# Permitting decisions

## Refusal

We have decided to refuse the variation for Bankwood Lane Waste Treatment and Processing Centre operated by Eco-Power Environmental Limited.

The location of the facility is Bankwood Lane Industrial Estate, Bankwood Lane, Rossington, Doncaster, DN11 0PS.

**Site Layout 2 – October 2019:**

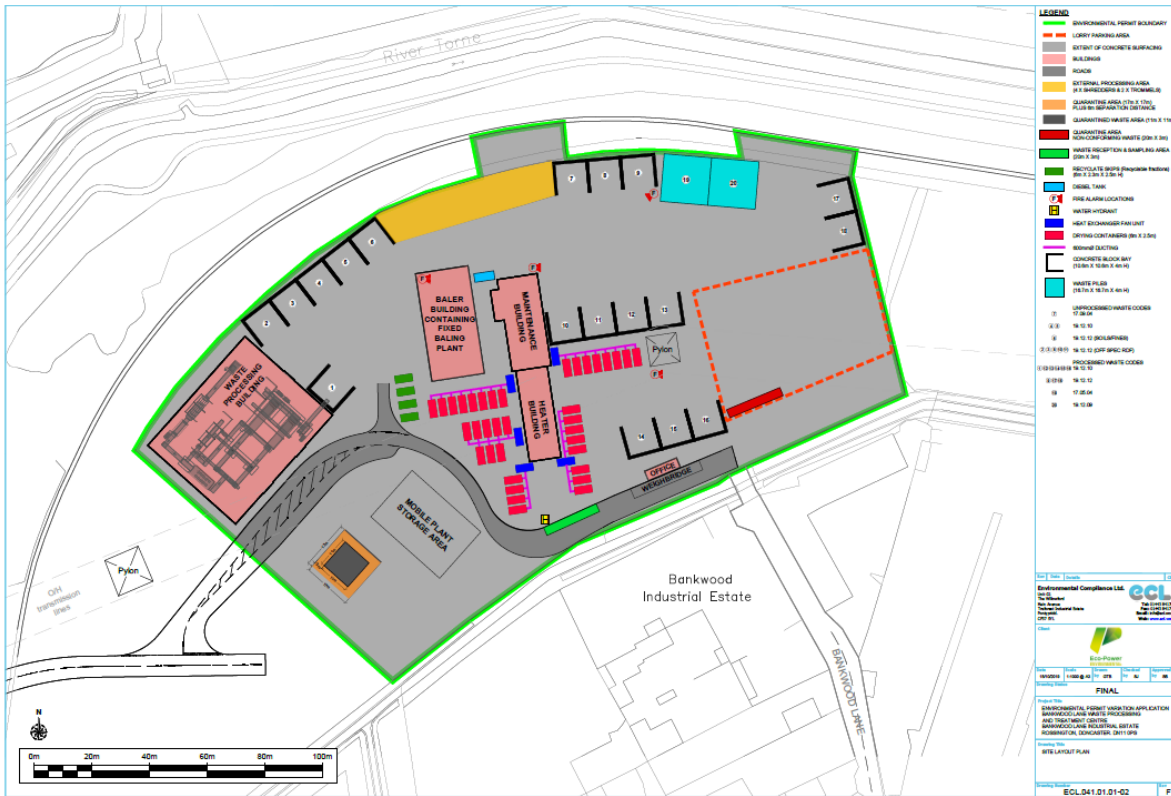
Each of these changes have an impact on potential environmental impacts from site operations such as:

- Dust and odour (location of waste storage and processing areas)
- Fire prevention and waste acceptance (quarantine areas)
- Noise management (removal of attenuation block wall)
- Air quality (SRF drying infrastructure).
